MINUTES FROM 12 SEPTEMBER 1994 BASE REALIGNMENT AND CLOSURE TEAM
MEETING NTC ORLANDO FL
9/12/1994
ABB ENVIRONMENTAL

Subject: Minutes of the September 12/13 NTC, Orlando BRAC Clean-up Team Meeting

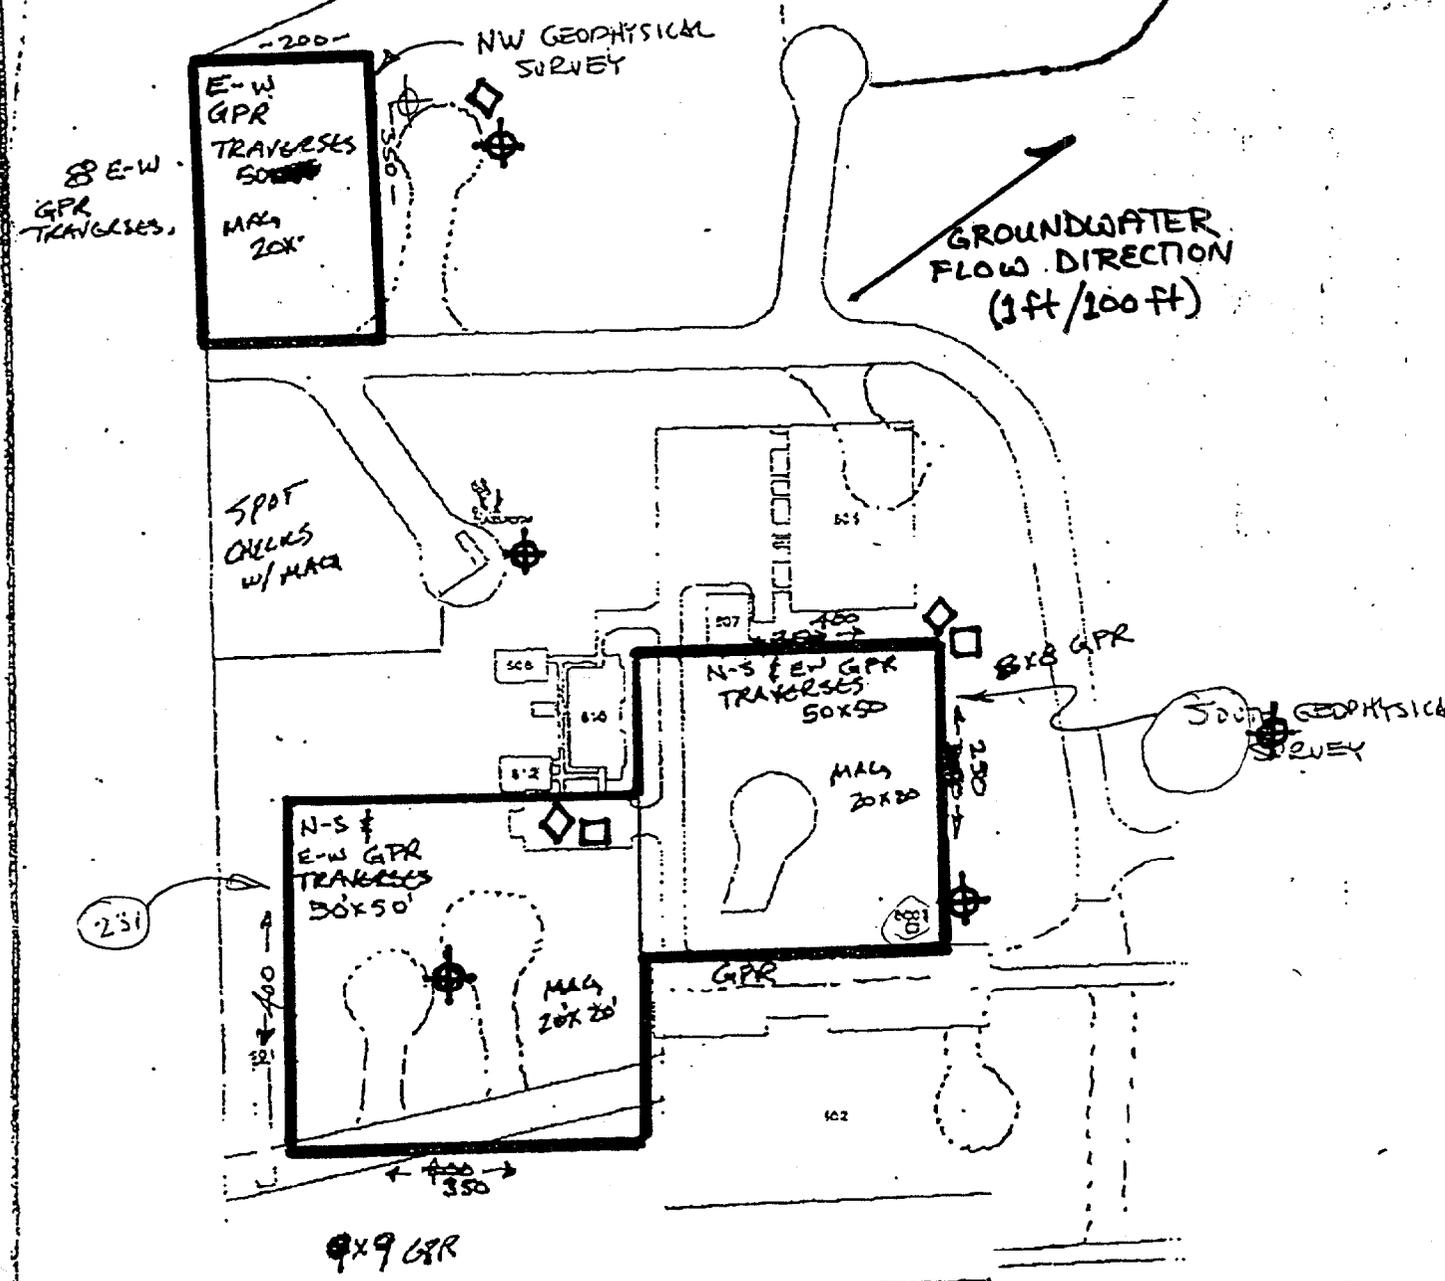
The first order of business was an update on the status of the Group I Site Screening efforts. Philip Georgariou reviewed the results of the geophysical surveys that were conducted. The potential landfill at Herndon was confirmed and a discussion was held relative to what the next steps should be, given that Herndon Annex has such a high transfer/lease priority. The need for additional wells was discussed at some length. With the wells that have just recently been installed, there would still be insufficient information to ascertain whether the former landfill is leaching contaminants to the groundwater. Five additional wells were outlined (see attached depiction) that would be required to definitively write the parcel off as transferrable. If the current and additional wells indicate that no leaching is taking place, the parcel could be transferred with deed restrictions/covenants that highlighted past land-filling practices and cautioned against intrusive work. If the wells indicate that leaching has in fact, taken place, then the area would be referred to additional investigation, such as an RI/FS. The BCT agreed to wait until analytical results from the currently installed, and the additional wells, are received before making plans for any additional work.
